Proposed Revisions to a Standard Plans Index

Index Number: 700-010
Sheet Number (s): 5
Index Title: Single Column Ground Signs

Change minimum Driven Post Hole Diameter to 12" min; Added new Note 2 to allow for a square option.

DRIVEN POST DETAIL (Frangible Post In Through Sidewalk Installations without Sidewalk Similar)

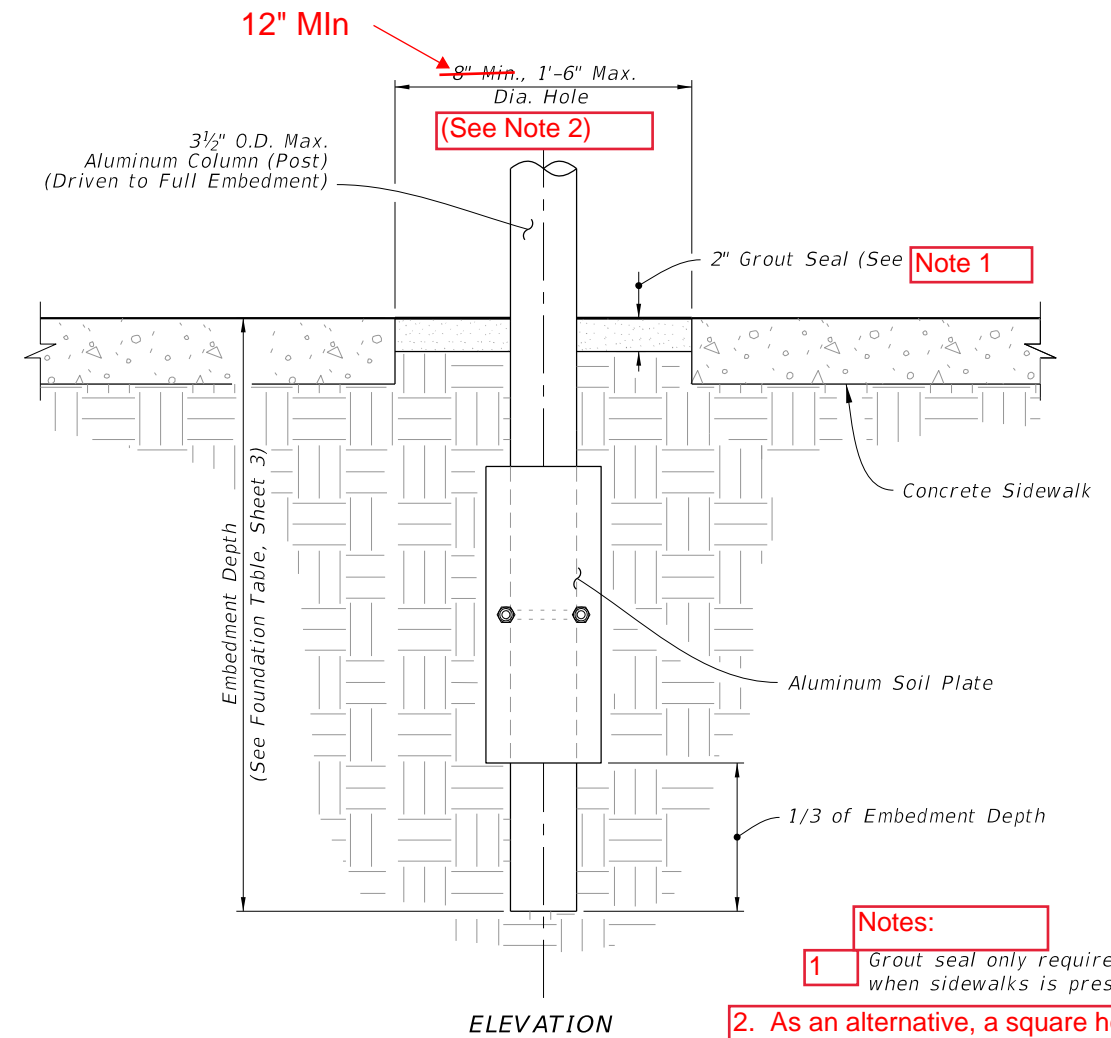
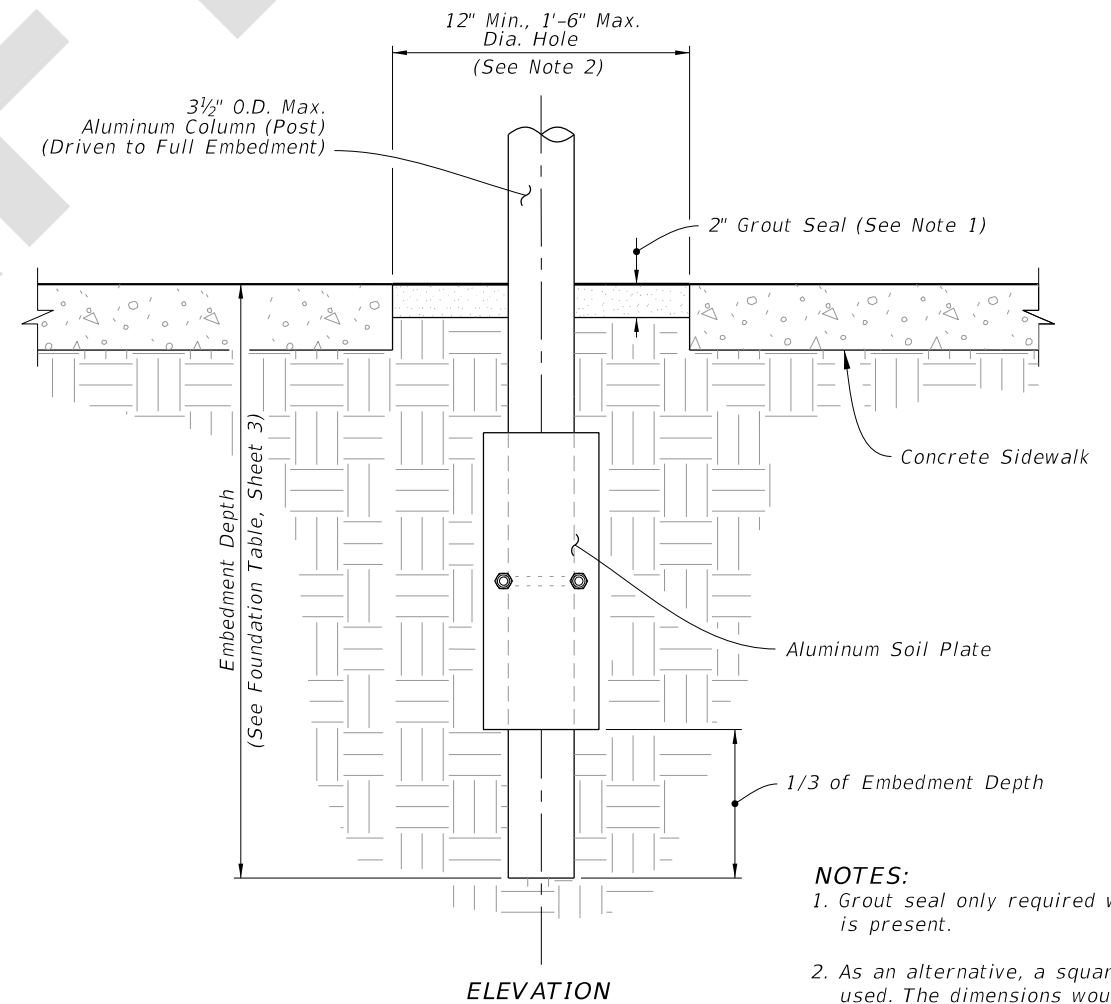
This change was requested by D7 Operations and coordinated with CO Maintenance and Construction. The 8" hole does not allow adequate space to remove old columns for replacement. Per a comment submitted by Industry, CO Maintenance requested that a square hole option be added.

- Notes:
- 1 Grout seal only required when sidewalks is present.
 2. As an alternative, a square hole may be used. The dimensions would remain, 12" minimum and 18" maximum.

NOTES:
1. Grout seal only required when sidewalks is present.
2. As an alternative, a square hole may be used. The dimensions would remain, 12" minimum and 18" maximum.
